Lower Ground

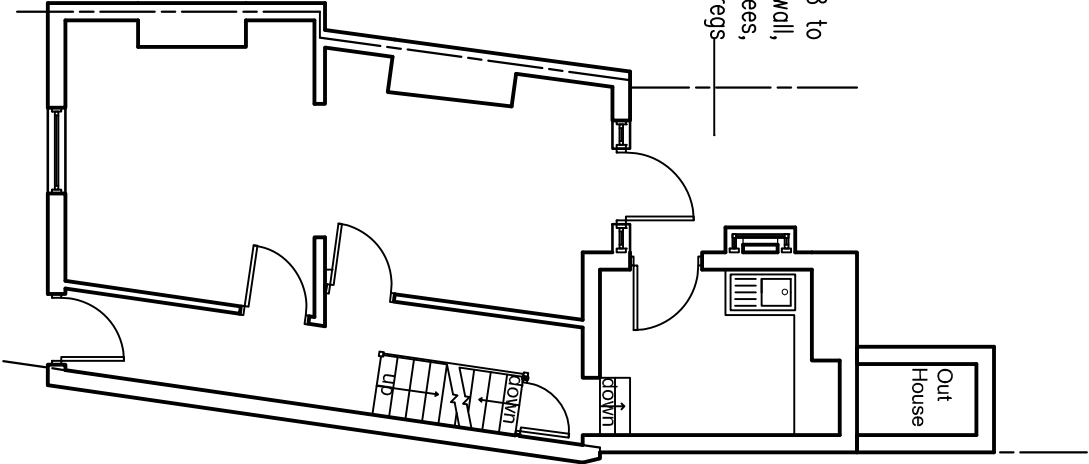
This measurement is actually 2300, I've left it at 2178 to reflect what the gap is near the end of the kitchen wall, i.e. kept the neighbours wall at 90 degrees, we will need to go back and re measure for building regs
